**Addendum h to
ASHRAE Guideline 36-2018**

Proposed Addendum h to Guideline 36-2018, High-Performance Sequences of Operation for HVAC Systems

**First Public Review (February 2020)
(Draft shows Proposed Changes to Current Guideline)**

Addendum h to Guideline 36-2018

Figure 5.5.5. Control Logic for Cooling Only VAV Zone

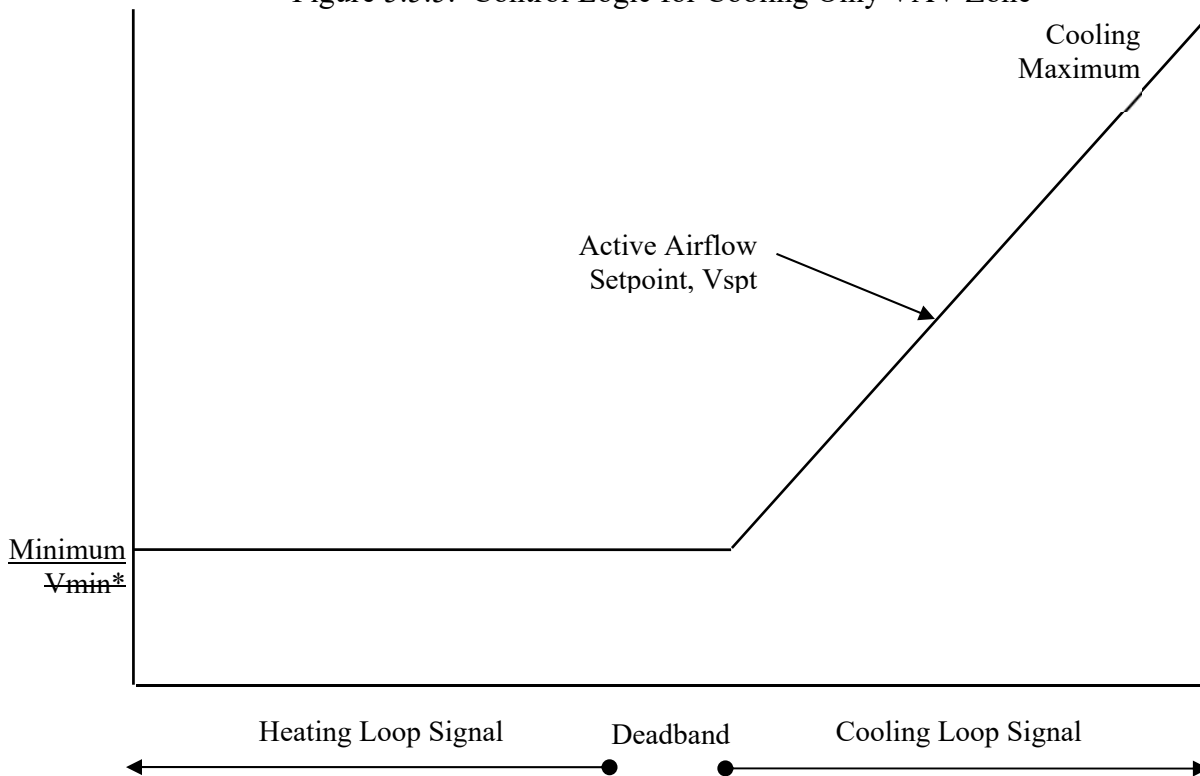
5.5.4 ~~Active maximum and minimum setpoints~~ endpoints used in the control logic depicted in Figure 5.5.5 below shall vary depending on the Mode of the Zone Group the zone is a part of:

5.5.5 Control logic is depicted schematically in Figure 5.5.5 below and described in the following sections. ~~Relative levels of various setpoints are depicted for Occupied Mode operation.~~

5.5.5.1 When the Zone State is Cooling, the Cooling Loop output shall be mapped to the active airflow

setpoint from the minimum endpoint to the cooling maximum endpoint ~~airflow setpoints~~.

5.5.5.2 When the Zone State is Deadband or Heating, the active airflow setpoint shall be the minimum endpoint ~~airflow setpoint~~.

5.5.5.3 When the Zone State is Heating, the active airflow setpoint shall be the minimum endpoint.

Figure 5.6.5. Control Logic for VAV Reheat Zone

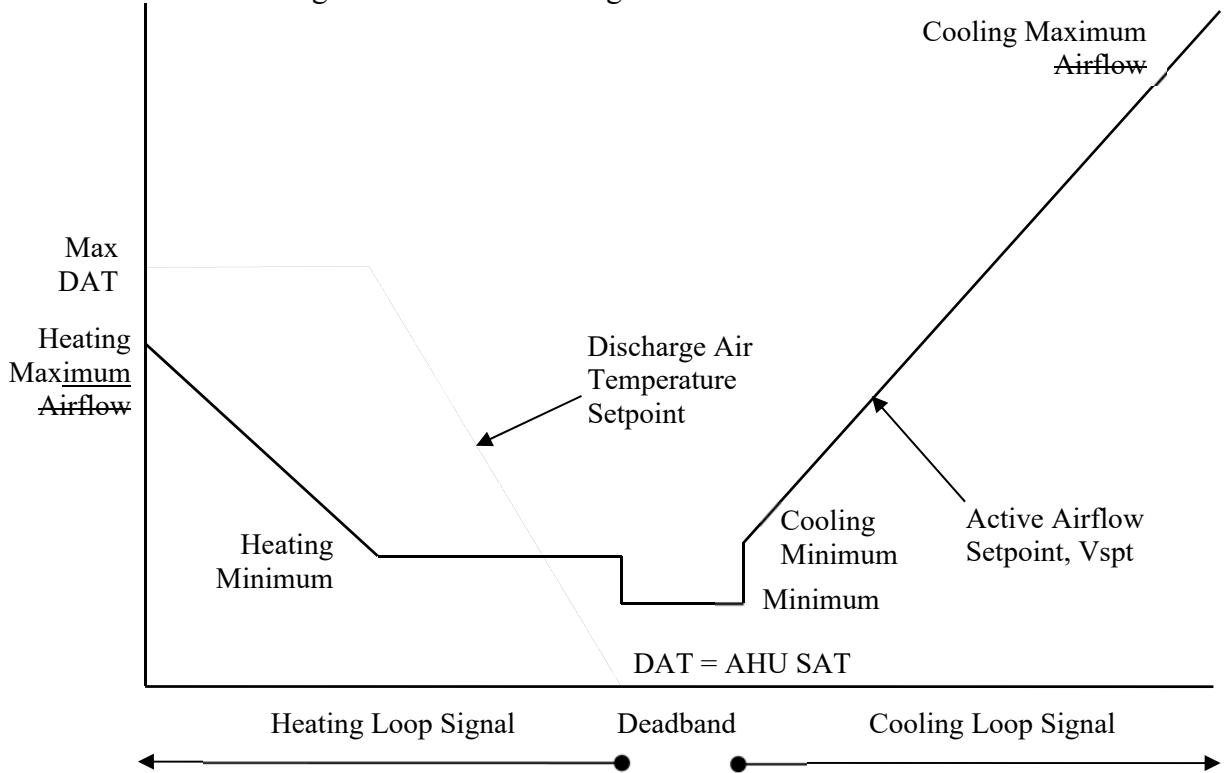
5.6.4 Active ~~maximum and minimum setpoints~~ endpoints used in the control logic depicted in Figure 5.6.5 below shall vary depending on the Mode of the Zone Group the zone is a part of:

5.6.5 Control logic is depicted schematically in Figure 5.6.5 below and described in the following sections. ~~Relative levels of various setpoints are depicted for Occupied Mode operation.~~

5.6.5.1 When the Zone State is Cooling, the Cooling Loop output shall be mapped to the active airflow setpoint from the cooling minimum endpoint to the cooling maximum endpoint airflow setpoints. Heating coil is disabled unless the discharge air temperature is below the minimum setpoint [see **Error! Reference source not found.** below].

5.6.5.2 When the Zone State is Deadband, the active airflow setpoint shall be the minimum endpoint airflow setpoint. Heating coil is disabled unless the discharge air temperature is below the minimum setpoint [see **Error! Reference source not found.** below].

2. From 51%-100%, if the discharge air temperature is greater than room temperature plus 3°C (5°F), the Heating Loop output shall reset the active airflow setpoint from the heating minimum endpoint ~~airflow setpoint~~ to the heating maximum endpoint ~~airflow setpoint~~.
3. The heating coil shall be modulated to maintain the discharge temperature at setpoint. (Directly controlling heating off the zone temperature control loop is not acceptable).

Figure 5.7.5-1. Control Logic for Constant Volume Parallel Fan-Powered VAV Zone ($OA_{min} > V_{min}$)

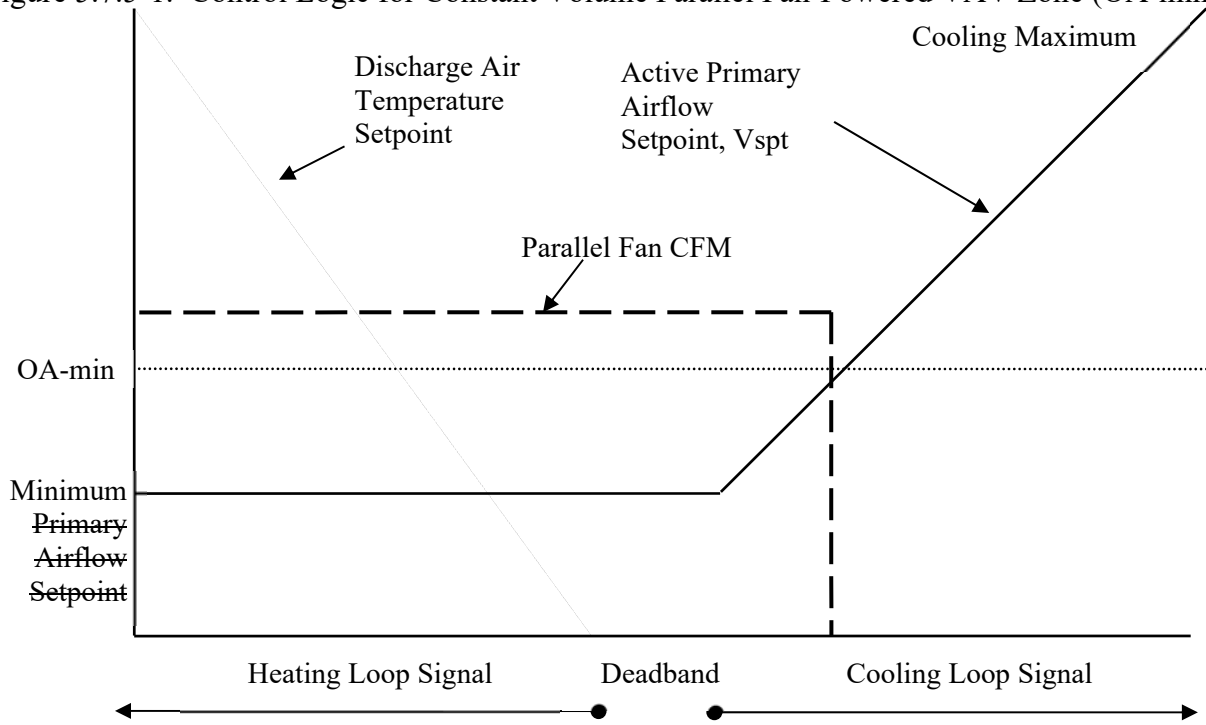
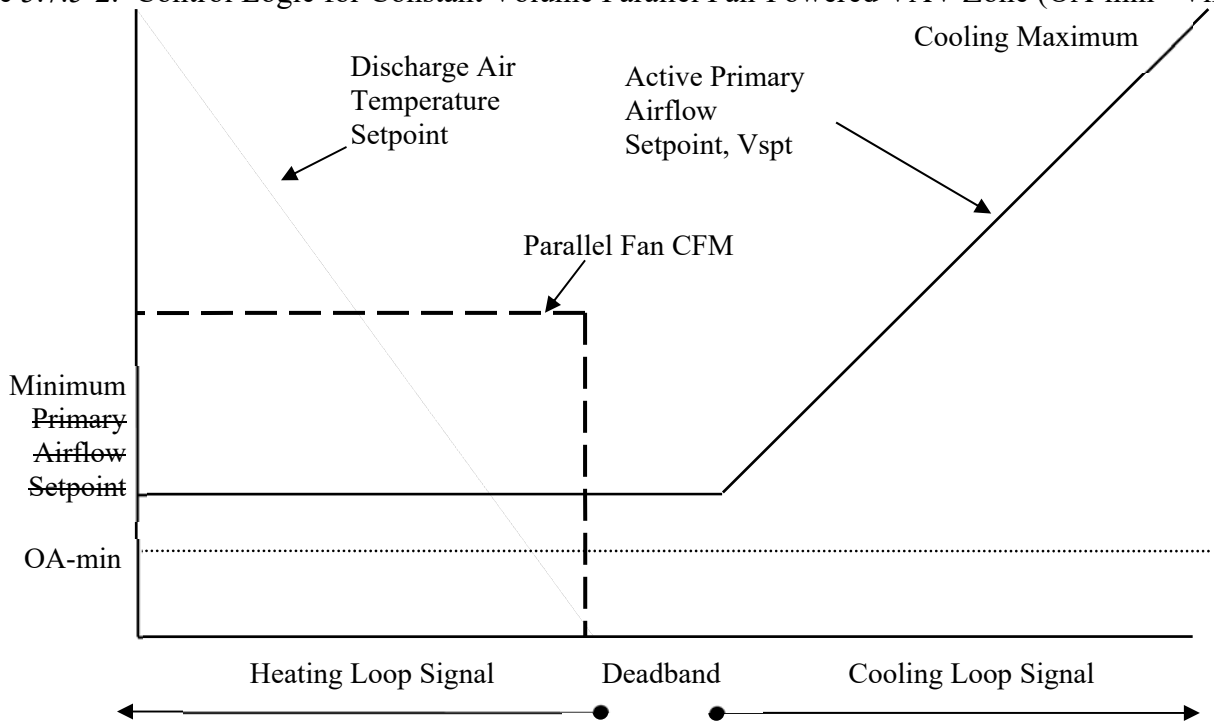
5.7.4 ~~Active maximum and minimum primary air setpoints endpoints~~ endpoints used in the control logic depicted in Figures 5.7.5-1 and 5.7.5-2 below shall vary depending on the Mode of the Zone Group the zone is a part of:

5.7.5 Control logic is depicted schematically in figures 5.7.5-1 and 5.7.5-2 below and described in the following sections. In the figures below, OA-min is Voz (if using ASHRAE Standard 62.1 ventilation logic) or Zone-Abs-OA-min (if using Title 24 ventilation logic).

minimum endpoint to the cooling maximum endpoint~~airflow setpoints~~.

- 1. The active primary airflow setpoint shall be the minimum endpoint~~airflow setpoint~~.

Figure 5.8.5. Control Logic for Variable Volume Parallel Fan-Powered VAV Zone

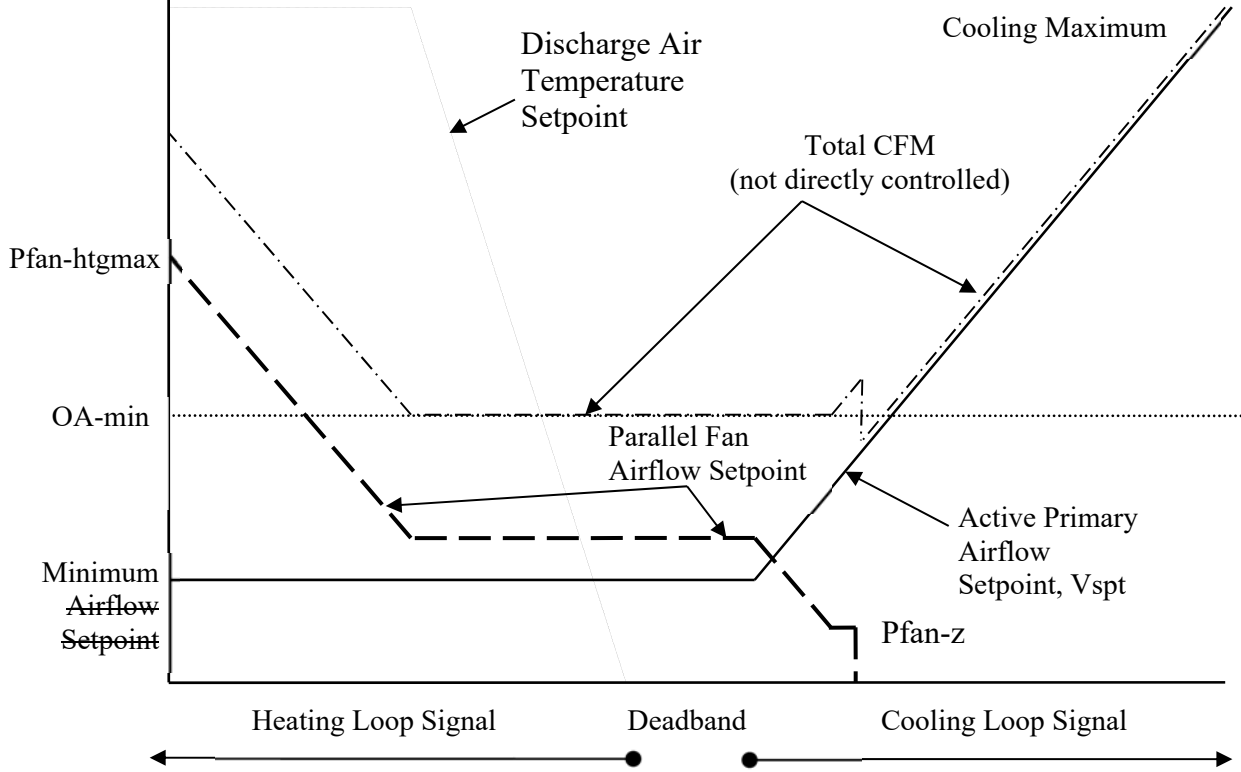
5.8.4 Active maximum and minimum primary air setpoints~~endpoints~~ used in the control logic depicted in Figure 5.8.5 below shall vary depending on the Mode of the Zone Group the zone is a part of:

5.8.5 Control logic is depicted schematically in figure 5.8.5 below and described in the following sections. ~~Relative levels of various setpoints are depicted for Occupied Mode operation.~~ In the figure below, OA-min is Voz (if using ASHRAE Standard 62.1 ventilation logic) or Zone-Abs-OA-min (if using Title 24 ventilation logic).

1. The Cooling Loop output shall be mapped to the active airflow setpoint from the minimum endpoint to the cooling maximum endpoint airflow setpoints.
 - a. If supply air temperature from the air handler is greater than room temperature, the active primary cooling supply airflow setpoint shall be no higher than the minimum endpoint.

2. Heating coil is off.
3. If ventilation is according to ASHRAE Standard 62.1-2016: In Occupied Mode only, parallel fan starts when primary airflow drops below V_{oz} minus one half of $Pfan-z$ and shuts off when primary airflow rises above V_{oz} . Fan airflow rate setpoint is equal to V_{oz} minus the active ~~current~~ primary airflow setpoint.

4. If ventilation is according to California Title 24: In Occupied Mode only, parallel fan starts when primary airflow drops below $Zone-Abs-OA-min$ minus one half of $Pfan-z$ and shuts off when primary airflow rises above $Zone-Abs-OA-min$. Fan airflow rate setpoint is equal to $Zone-Abs-OA-min$ minus the active ~~current~~ primary airflow setpoint.

1. The active primary airflow setpoint shall be the minimum endpoint~~airflow~~ setpoint.
2. Heating coil is off.
3. If ventilation is according to ASHRAE Standard 62.1-2016, parallel fan runs if the active primary airflow setpoint is below Voz. Fan airflow rate setpoint is equal to Voz minus the active~~current~~ primary airflow setpoint.
4. If ventilation is according to California Title 24: In Occupied Mode only, parallel fan runs if the active primary airflow setpoint is below Zone-Abs-OA-min. Fan airflow rate setpoint is equal to Zone-Abs-OA-min minus the active~~current~~ primary airflow setpoint.

Figure 5.9.5. Control Logic for Constant Volume Series Fan-Powered VAV Zone

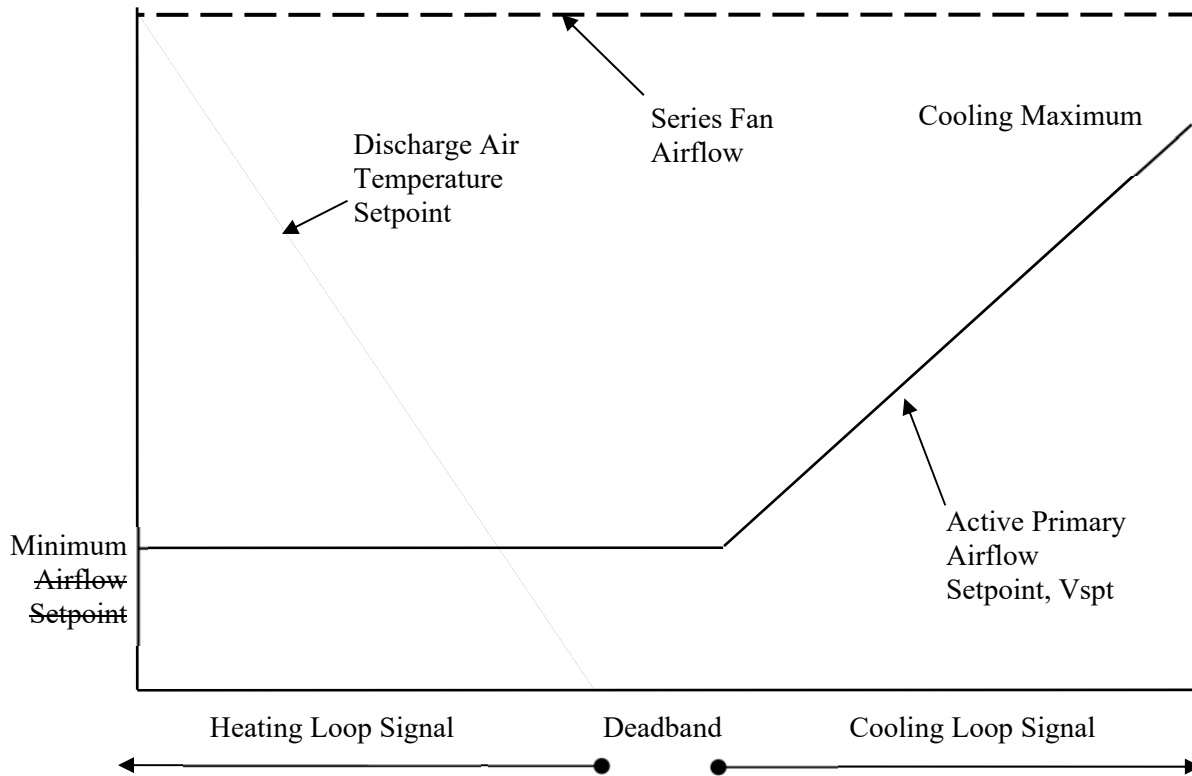
- 5.9.4 Active ~~maximum and minimum~~ primary air setpoints~~endpoints~~ used in the control logic depicted in Figure 5.9.5 below shall vary depending on the Mode of the Zone Group the zone is a part of:

5.9.5 Control logic is depicted schematically in the figure below and described in the following sections.

1. The Cooling Loop output shall be mapped to the active primary airflow setpoint from the minimum endpoint to the cooling maximum endpoint airflow setpoints.
 - a. If supply air temperature from the air handler is greater than room temperature, the active primary cooling supply airflow setpoint shall be no higher than the minimum endpoint.
2. Heating coil is off.

1. The active primary airflow setpoint shall be the minimum endpoint airflow setpoint.
2. Heating coil is off.

Figure 5.10.5. Control Logic for Variable Volume Series Fan-Powered VAV Zone

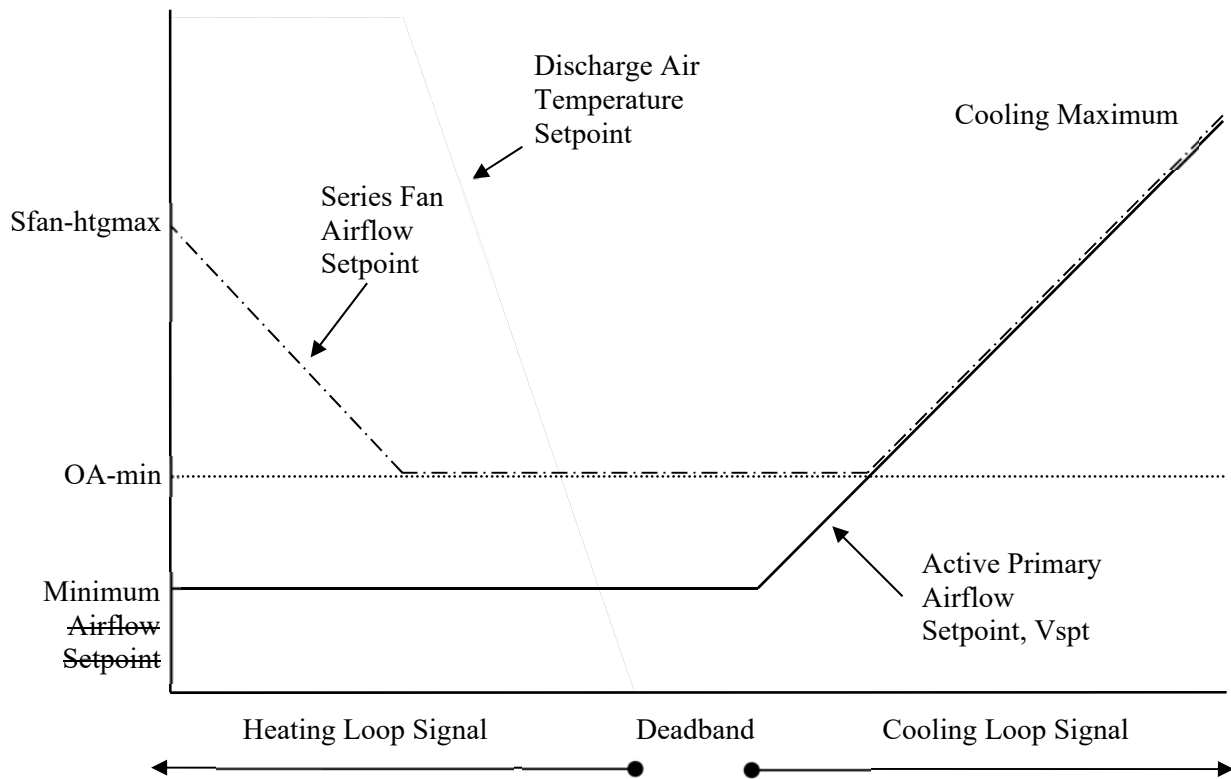
5.10.4 Active ~~maximum and minimum primary air setpoints~~endpoints used in the control logic depicted in Figure 5.10.5 below shall vary depending on the Mode of the Zone Group the zone is a part of:

5.10.5 Control logic is depicted schematically in figure 5.10.5 below and described in the following sections. ~~Relative levels of various setpoints are depicted for Occupied Mode operation.~~ In the figure below, OA-min is Voz (if using ASHRAE Standard 62.1 ventilation logic) or Zone-Abs-OA-min (if using Title 24 ventilation logic).

1. The Cooling Loop output shall be mapped to the active primary airflow setpoint from the cooling minimum endpoint to the cooling maximum endpoint airflow setpoints.
 - a. If supply air temperature from the air handler is greater than room temperature, the active primary airflow setpoint shall be no higher than the minimum endpoint and the series fan airflow setpoint shall be no higher than OA-min.
2. The series fan airflow setpoint shall be the larger of OA-min and the active primary airflow setpoint.
3. Heating coil is off.

1. The active primary airflow setpoint shall be the minimum endpoint ~~airflow setpoint~~.
2. The series fan airflow setpoint shall be equal to OA-min.
3. Heating coil is off.

1. From 0-50%, the Heating Loop output shall reset the discharge temperature setpoint from the current AHU SAT setpoint to a maximum of MaxΔT above space temperature setpoint. The active primary airflow setpoint shall be the minimum ~~endpoint~~ airflow setpoint, and the series fan airflow setpoint shall be OA-min.
2. From 50-100%, the Heating Loop output shall reset the series fan airflow setpoint from OA-min to a Sfan-htgmax. The active primary airflow setpoint shall be the minimum ~~endpoint~~ airflow setpoint.
3. The heating coil shall be modulated to maintain the discharge temperature at setpoint. (Directly controlling heating off zone temperature control loop is not acceptable).
